**Maine DOT Bar Harbor Route 3 Gateway Project Advisory Committee
Tuesday, February 8, 2011 9:30-11:30 AM
Church of Our Father**

Minutes

Review Draft Report and seek consensus for recommendations:

Highbrook Road Section

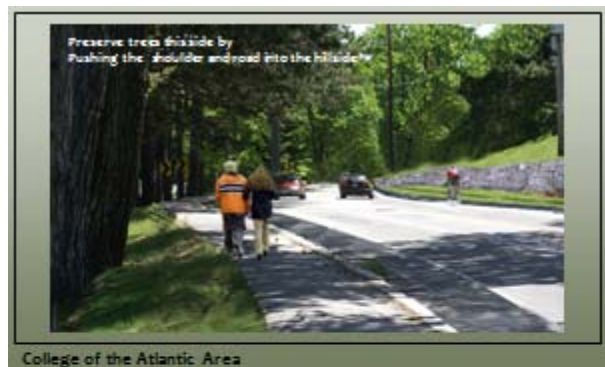
Questions

- What materials will be used for sidewalks
 - MaineDOT will provide a basic asphalt sidewalk and cement curbing
 - Town can upgrade if the town pays the difference
- If existing curbing is granite, it will be repaired or replaced with material of equal or better value.
- Needs to get some pedestrians to a bus stop on Highbrook Road
- Needs to get other pedestrians to the cross walk and sidewalk on the shore side.
